# Access Compliance Report

## Public Rights-of-Way

Intersection ID: 27962	Main Street: PINE_VALLEY_CLUB_DR	Cross Street: ROYAL_ABERDEEN_CT	Location: SE
ADA ID: 97B4E4A34503	Ramp Type: Perp	Initial Pass/Fail: Fail	Overall Compliance: No
Severity Score: 10			
Codes/Mitigation Info/Possible Solution		Field Measurements/Component Compliance

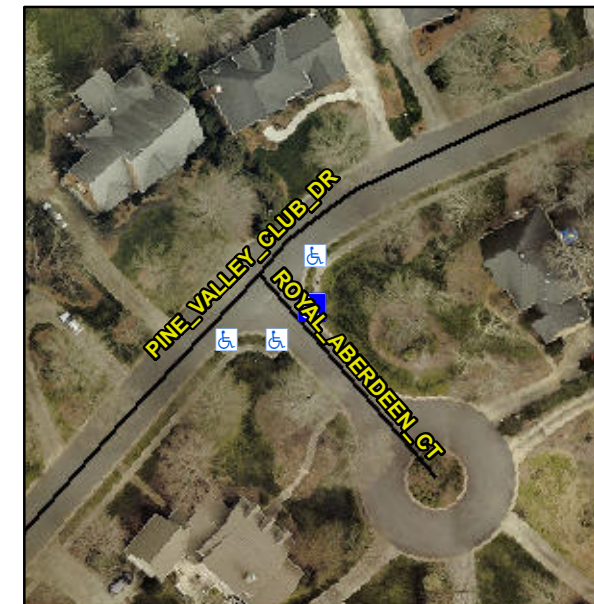
**Not Found, R304.5.1, R304.5.3**

Compliance	Description	Data	Compliance	Description	Data
N/A	Ramp Length (in)	96.0	Yes	Ramp Slope (%)	6.5
No	Ramp Width (in)	43.0	No	Ramp XSlope (%)	2.3
N/A	Flare Type LT	N/A	N/A	Flare Type RT	N/A
N/A	Flare Slope LT (%)	N/A	N/A	Flare Slope RT (%)	N/A
N/A	Flare Traversable LT?	N/A	N/A	Flare Traversable RT?	N/A
N/A	Landing Length (in)	N/A	N/A	DWS Provided?	N/A
N/A	Landing Width (in)	N/A	N/A	DWS Contrast?	N/A
N/A	Landing Slope (%)	N/A	N/A	DWS Length (in)	N/A
N/A	Landing X Slope (%)	N/A	N/A	DWS Full Width?	N/A
N/A	Landing Curb? (Y/N)	N/A	N/A	DWS Offset (in)	N/A
N/A	Shared Landing?	N/A			
N/A	Gutter Ponding?	N/A	N/A	Gutter Slope (%)	N/A
N/A	Gutter Lip Ht (in)	N/A	N/A	Gutter X Slope (%)	N/A
N/A	Painted X Walk1?	No	N/A	Painted X Walk2?	N/A
	X Walk 1 Direction	To SW		X Walk 2 Direction	N/A
N/A	X Walk 1 Width (in)	N/A	N/A	X Walk 2 Width (in)	N/A
	X Walk 1 Slope (%)	0.2		X Walk 2 Slope (%)	N/A
	X Walk 1 X Slope (%)	0.3		X Walk 2 X Slope (%)	N/A

**Remove & Replace Entire Ramp.**
